DESIGNED BY: Tjm  
CHECKED BY: Tjm  
DRAWN BY: Tjm  
DATE: Aug, 83  
SHEET: 27A OF 27 SHEETS  
FILE NO: ER31102

CITY OF ELK RIVER  
SANITARY SEWER (CHANGE ORDER #1)  
GATES AVE. & 3RD AVE. NW

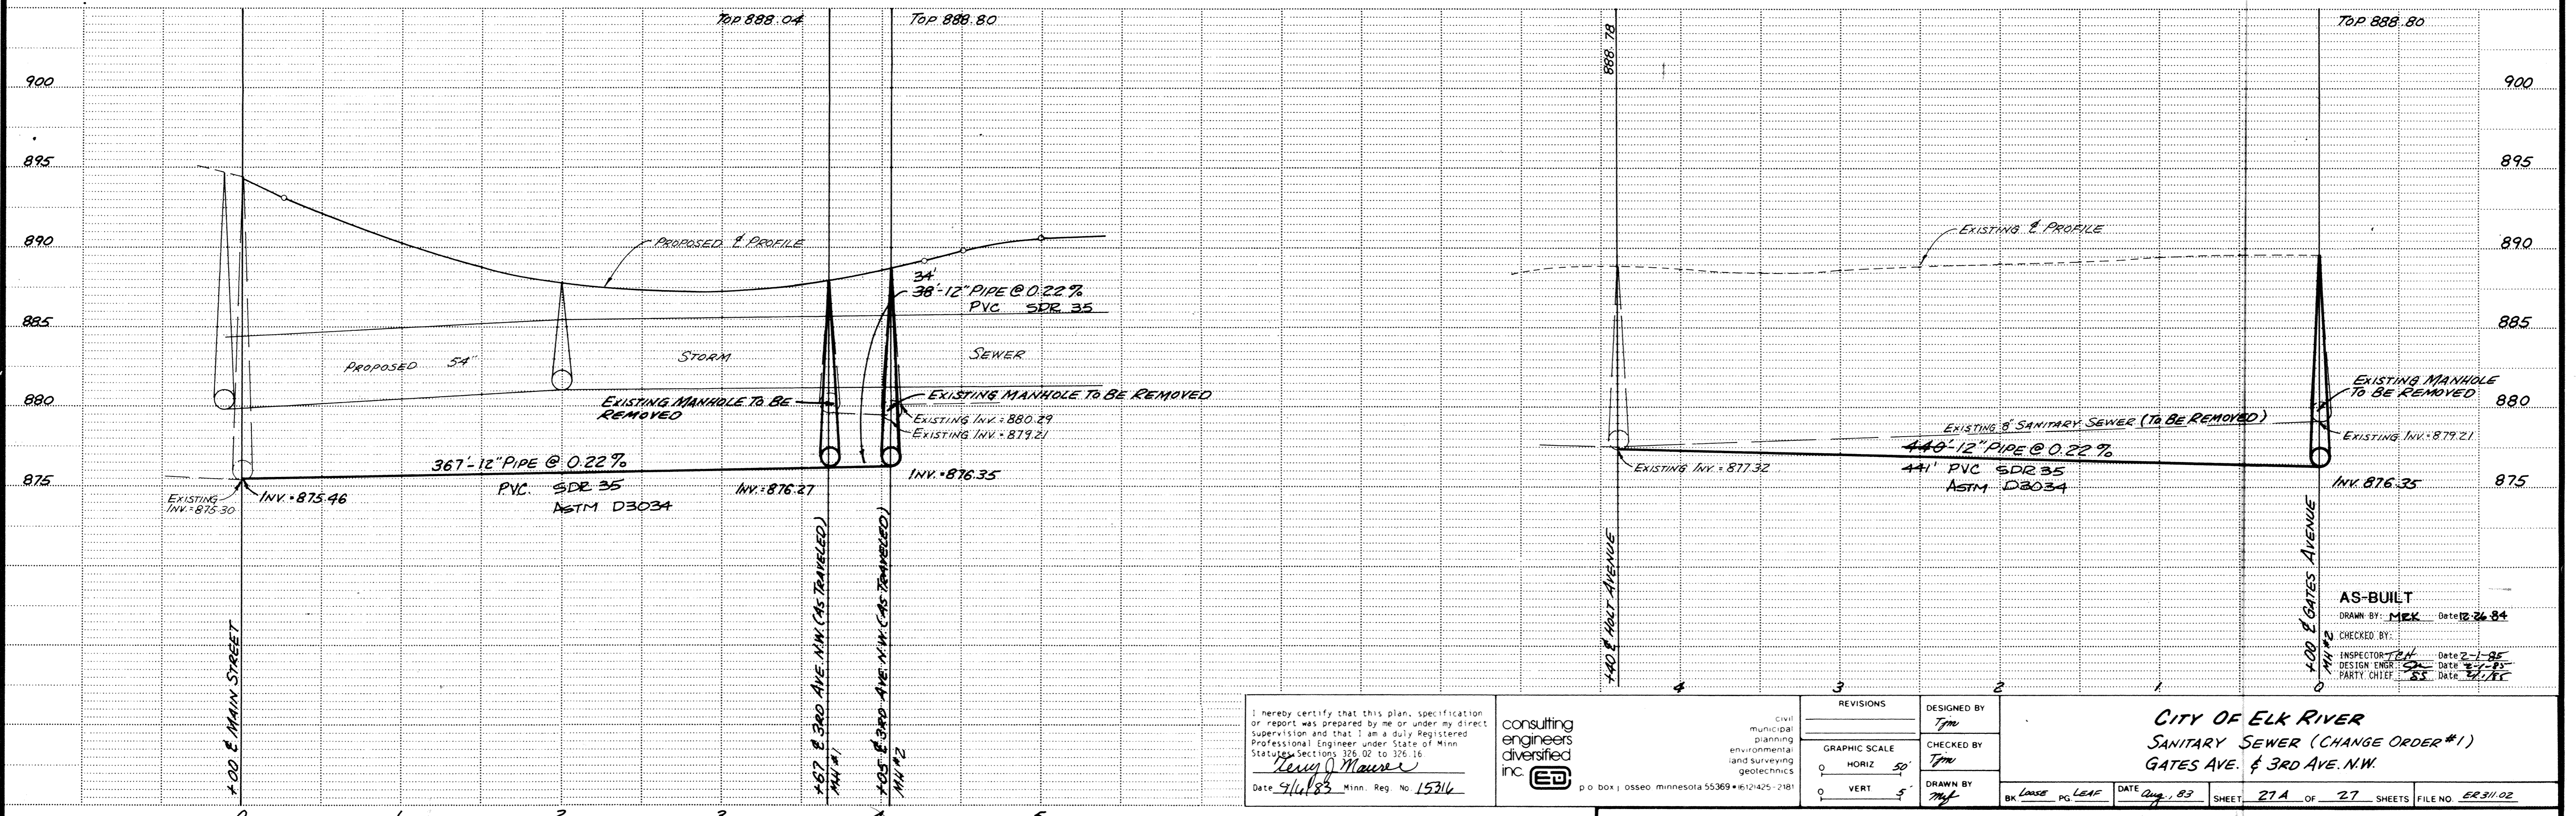
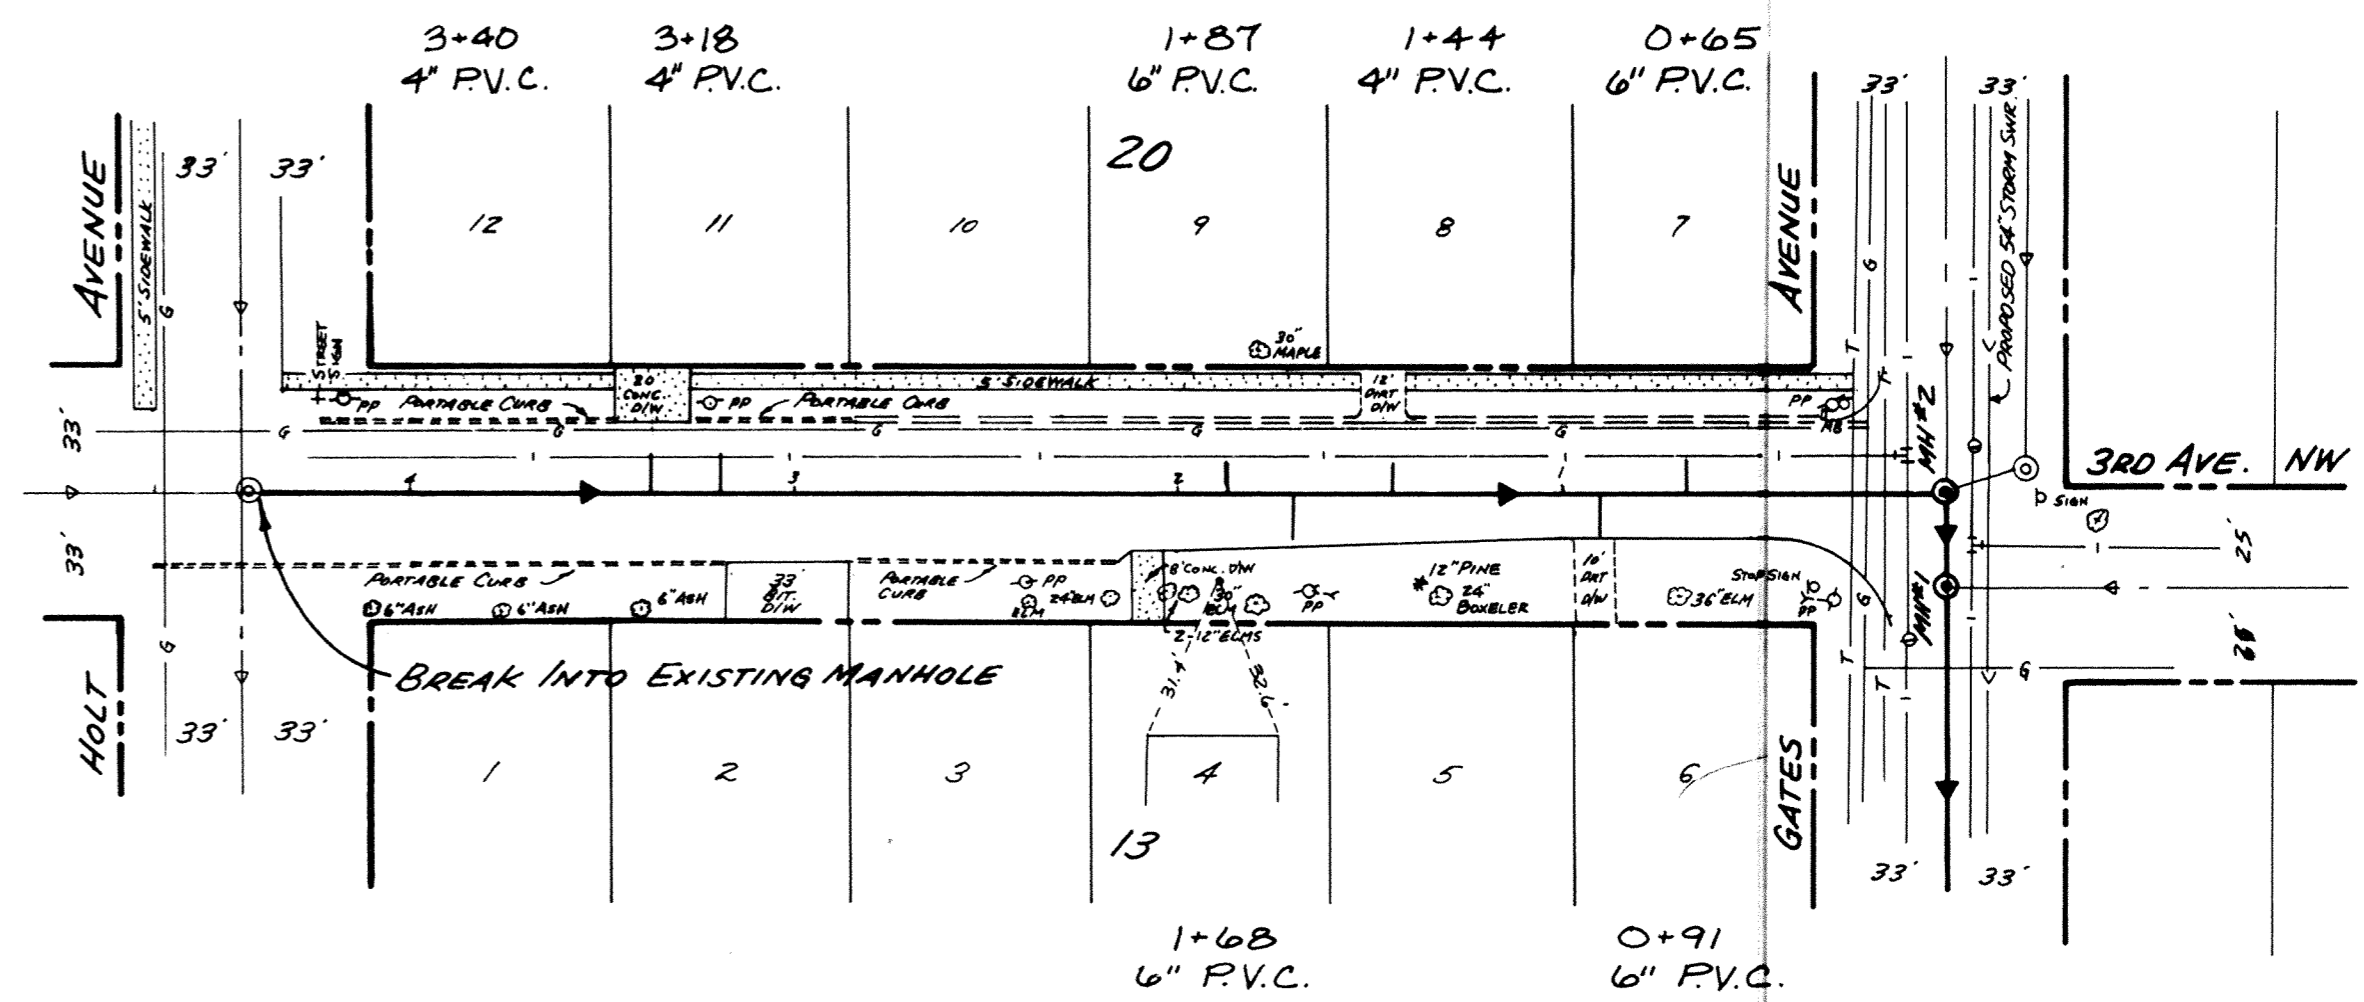
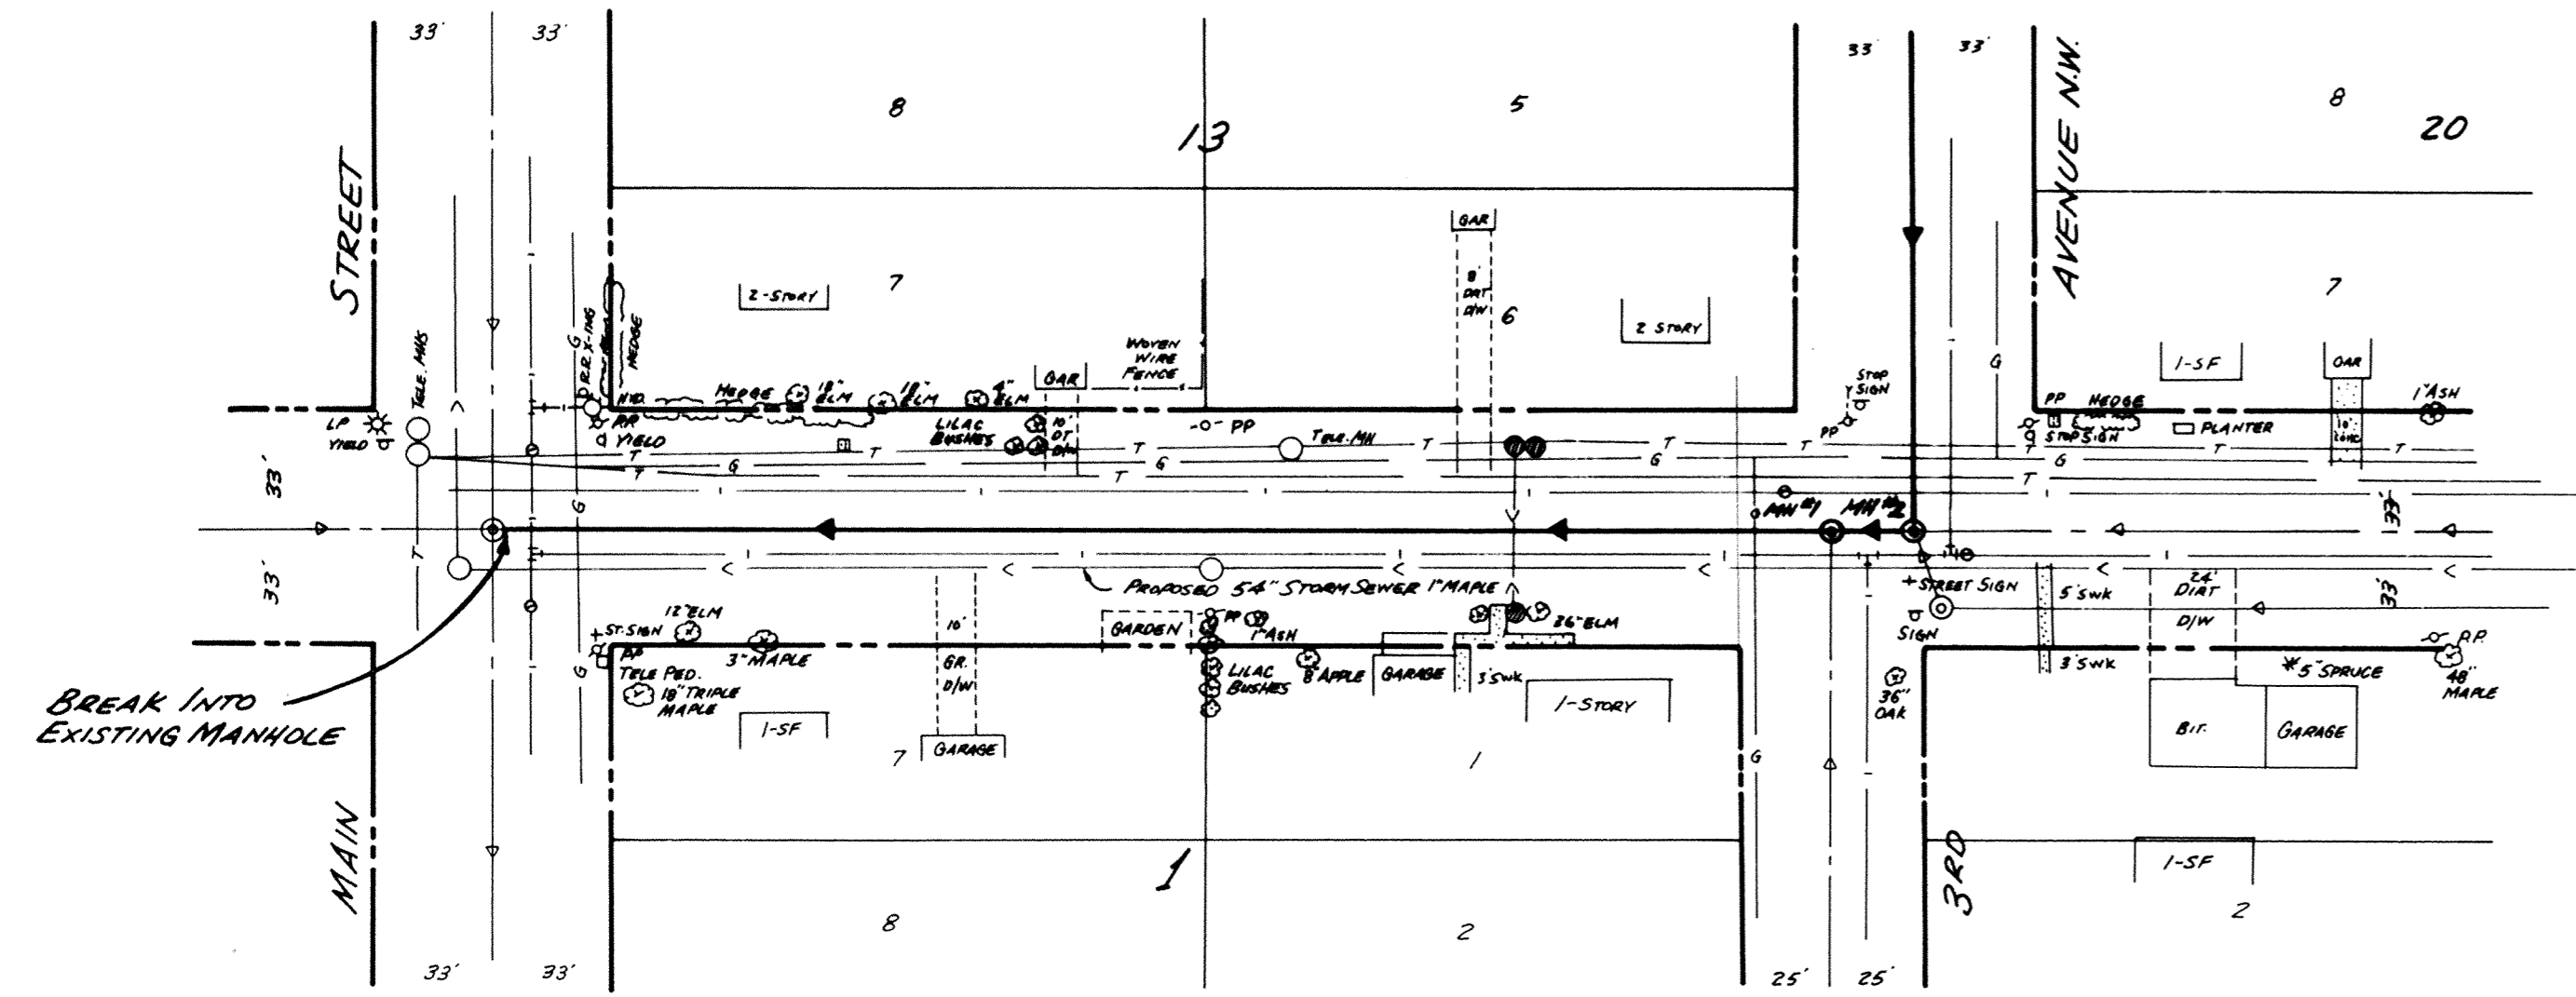
1. Street area disturb on 3rd Avenue to be restored with 4" Class 5 base and 2" Bituminous Surfacing (MnDOT 2341).
2. Existing Sanitary Sewer services on 3rd Avenue to be connected to the proposed 12" line.
